PLANNING PROPOSAL – KENTWELL AVENUE, SHOWGROUND ROAD, PENNANT STREET AND CASTLE STREET, CASTLE HILL (3/2023/PLP)

RE: "SITE B" PLANNING PROPOSAL – RESPONSE TO COUNCIL RFI

Reference: Planning Proposal – Kentwell Avenue, Showground Road, Pennant Street and Castle Street, Castle Hill (3/2023/PLP)

Figure 6 – Initially Proposed Concept Layout (Source: Stantec TIAR for Planning Proposal)

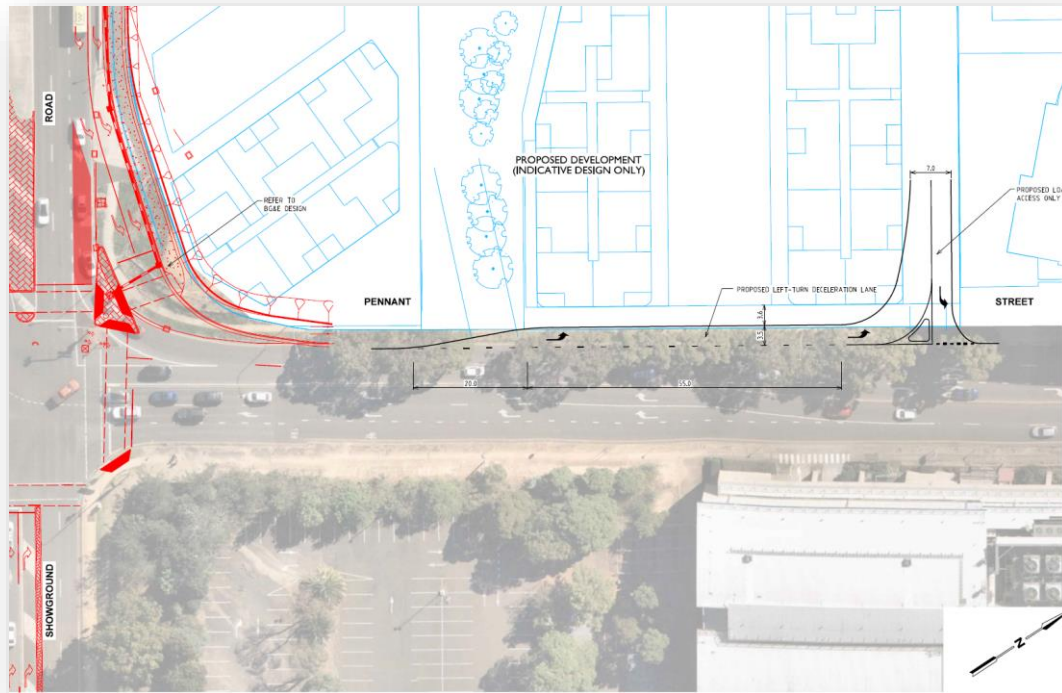
- ***Deceleration Turning Lane Length***
 - Reference to Drawing No. 300303493-19-05 included as an appendix to the August 2022 Stantec TIAR, and reproduced below in Figure 6, indicates that a 75m left turn deceleration lane is proposed at the left in / left out access.

I also consider it prudent to note that the proposed left-in / left-out vehicle access will be the only vehicle access (including to loading docks and other car parks) along the length of Pennant Street between Showground Road and Old Northern Road that has a deceleration lane. That is, the vehicle access has been designed to a standard that far exceeds what exists on this road at present.

In this context, we consider the proposed vehicle access design is appropriate.

Figure 1 – Potential Long-term (Ultimate) Concept Layout

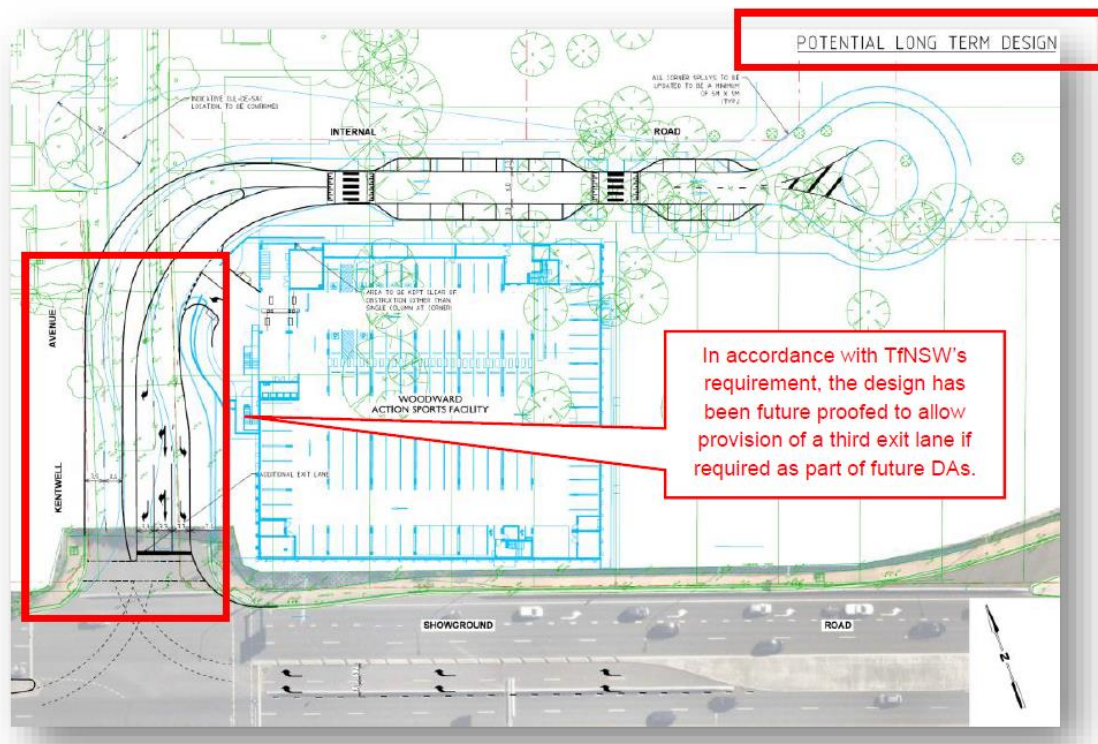
We note that the proponent has acknowledged the potential long term (ultimate) concept layout which highlights the future provision of 3-approach and 2-departure lanes on the Kentwell Avenue leg of this intersection, see **Figure 1** on the following page.

TfNSW also supports the proponent’s statement that this matter (agreed ultimate layout) can be addressed after the Gateway Determination via a minor revision to the Planning Proposal documentation.

Figure 4. Proposed cycle link (page 8/26 of 20240620 - B5. PP Appendix D_Landscape Masterplan - Site B, Castle Hill_PP-2022-3644.pdf)

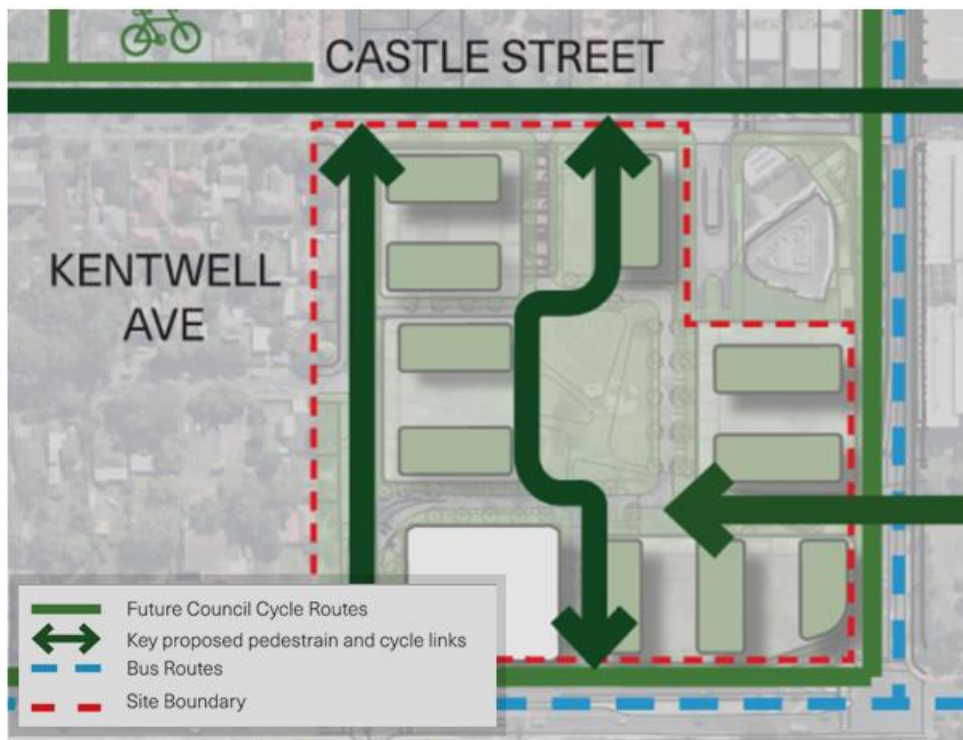
- **Active Transport interactions / concerns** - We note that there is a proposed future Council cycle route along Pennant Street as shown within the Figure below which has been extracted from the Landscape Masterplan Report. A proposed loading dock access on this part of Pennant Street would clearly interfere with future cyclists. Therefore, relocating the Loading Dock access to the proposed internal road network would avoid the abovementioned conflicts with Council's proposed future cycle route.

We understand that Council's endorsed Castle Hill Precinct Plan indicates that it no longer plans for a future cycleway on Pennant Street – refer Figure 63 of the Plan which is reproduced below.

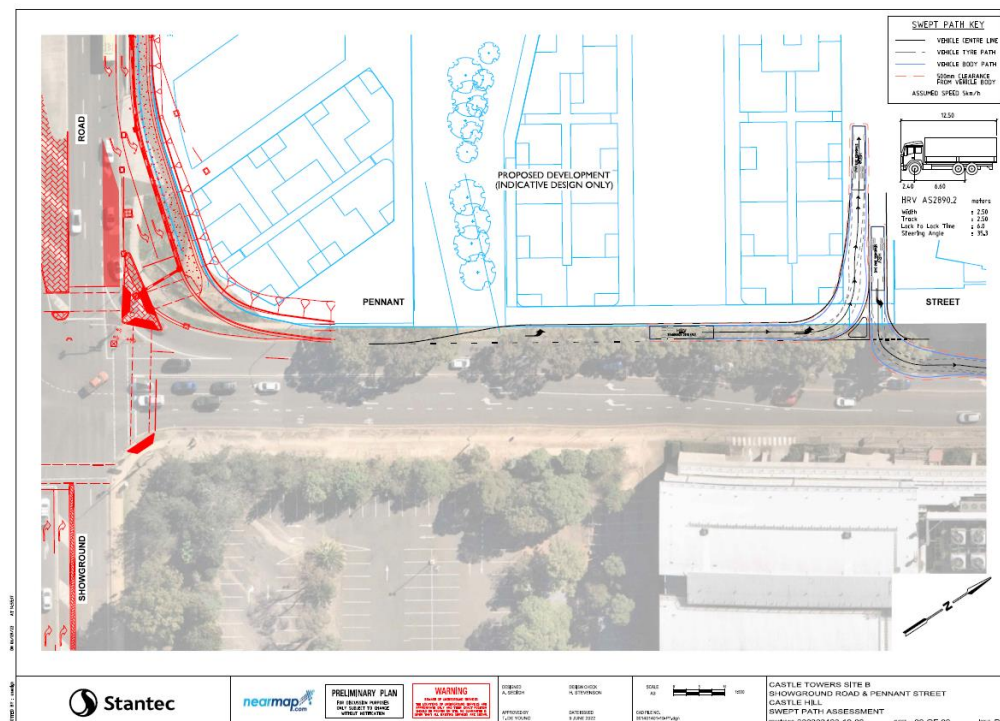
“If the vehicle access of Pennant Street is not provided, the internal road network would need to be redesigned to allow large trucks to circulate through the site and the built form would need to be modified to either provide ramps down to basement loading docks or the provision of at-grade loading docks.”

“This loading dock vehicle access is critical to achieve the design principles and objectives outlined above, as it minimises loading movements on the internal road network and therefore allows the streets to be designed better for pedestrians (e.g., relatively narrower road widths).”

Cross-Section for Location B ("Internal Link Street")

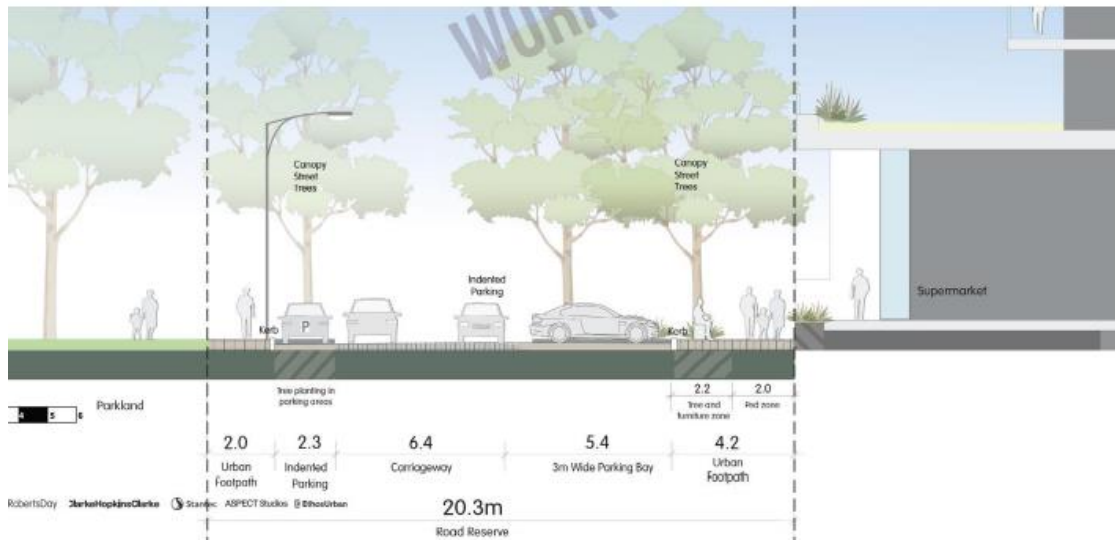
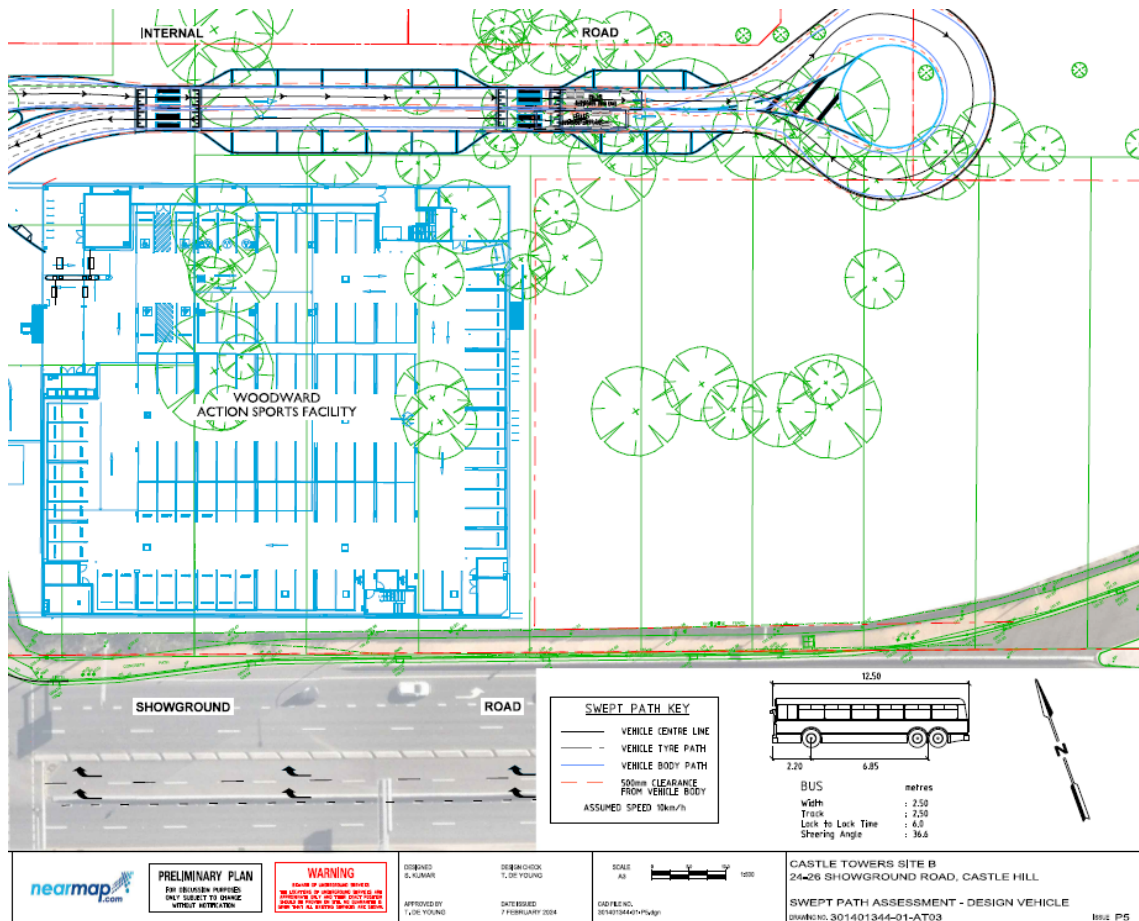
The use of 12.5m Heavy Rigid Vehicles (HRV) as the design swept paths for heavy vehicles entering / exiting the proposed loading dock off Pennant Street (as illustrated below).

The following internal road network details and Cross Sections “B” and “D” below, noting that the Cross-section Location B (Internal Link Street) allows for truck / bus parking on the southern side of the road at 3.0m width.
